EVERLIGHT Electronics Co., Ltd. Attn: No. 6-8, Zhonghua Rd., Shulin Dist., New Taipei City 23860, Taiwan, R.O.C. PHONE: 886-2-2685-6688 FAX: 886-2-2685-6699	
☒ PRODUCT/PROCESS CHANGE NOTIFICATION ☐ PRODUCT TERMINATION NOTIFICATION(※2)		
PCN tracking number: PCN-DC 20120222-1		DATE: 22th February, 2012
Contact: Jacky Cheng Title: CCBU PM E-mail: jackycheng@everlight.com	Phone: 886-2-2685-6688 ext: 6506 Fax: 886-2-2685-6699 Mobile: N/A	
Product influenced: ☐ Major change ☒ Minor change		
Product Identification: (e.g., affected supplier part number(s), affected product lines including specific package types, product family): Normal lamp products with under series: 204-15 Series 313 Series 3294-15 Series 333 Series 334-15 Series 383 Series 7324 Series 7343 Series		
Customer part number(s) (optional, if not required per agreed to customer criteria): N/A		
Method, if applicable, of identifying changed product: N/A

Reason for change(s): ☐ Products Package Outline Dimension ☐ Electrical/Optical Specification ☒ Material ☐ Equipment ☐ Data Sheet ☐ Packing ☐ Other	Detailed description: Due to the supplier makes change of the length of leadframe from 24mm to 16mm. We would like to inform affe

204-15 Series	
Before	After

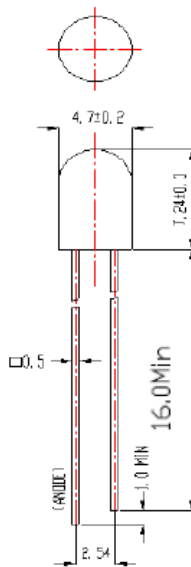
The following drawings demonstrated the dimension of products will be changed.
